Memorandum

RE: Change Order No. 2 Gilbert Trail Contracts 2014-03 and 2014-04

CHANGE ORDER

Gilbert Trestle Improvements

TRAIL ALIGNMENT EAST

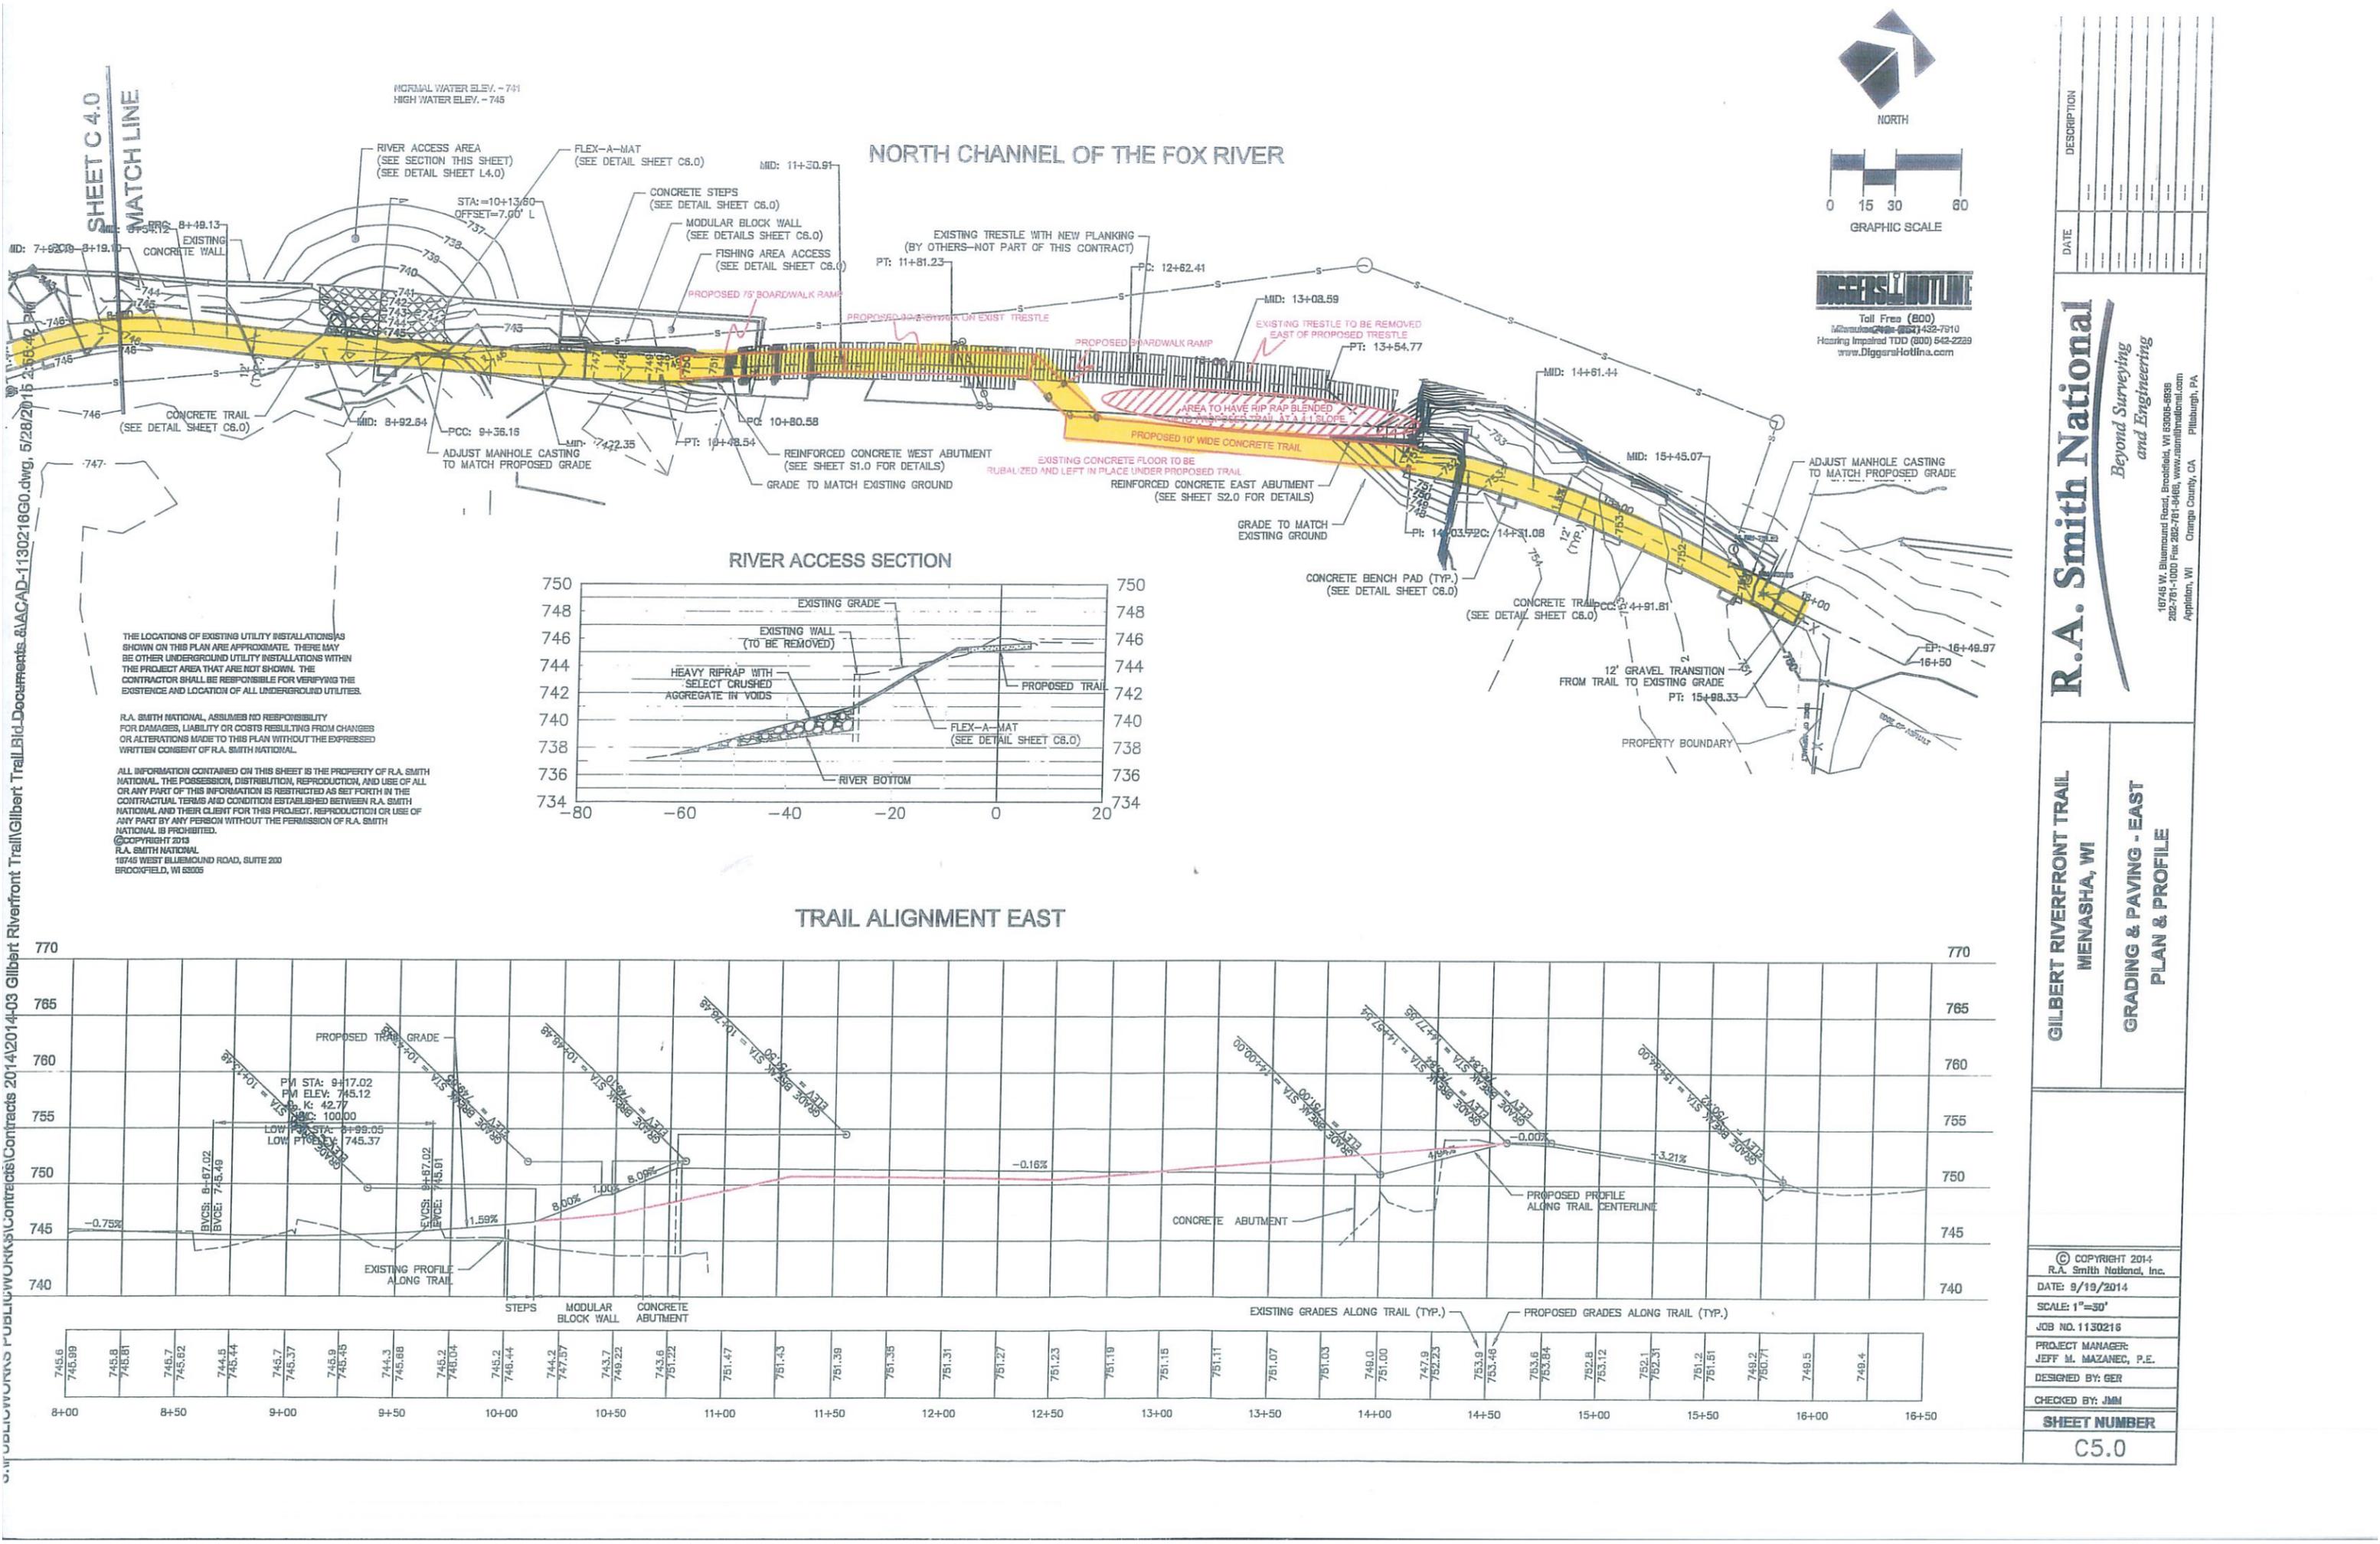
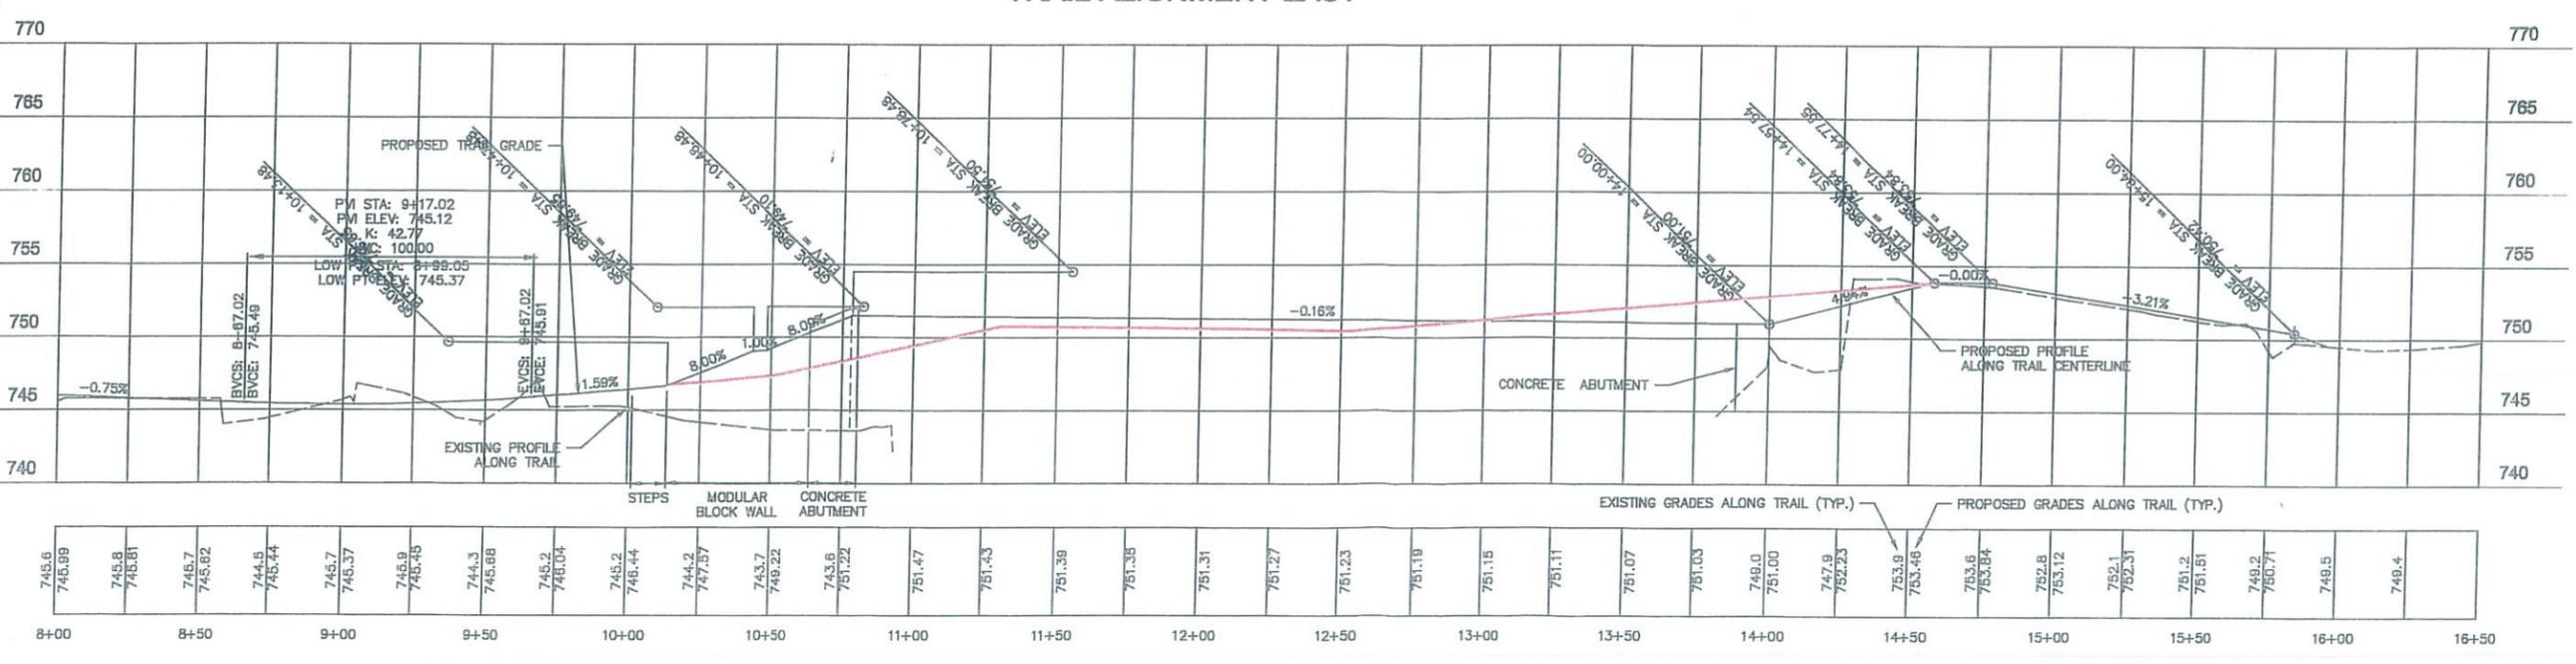
Attached is a drawing depicting the recommended new route of the trail relative to the proposed original route of the trail in the vicinity of the trestle. The angle of departure from the trestle with the new design was maintained at the same angle as the original to allow for a smooth transition on/off the trestle. There will be a need for the placement of

heavy rip rap along the river's edge adjacent to the base of the trail fill area east of the retained trestle section. The relocation of the trail to the south of the trestle can be accomplished within City owned property. The easternmost portion of the trail is not affected by the proposed relocation of the trail and its construction will still require additional land rights from the adjacent property owner. The property owner has indicated a willingness to cooperate with our needs in that area. The Department of Natural Resources was notified of the proposed changes and has approved them if we decide to pursue that option.
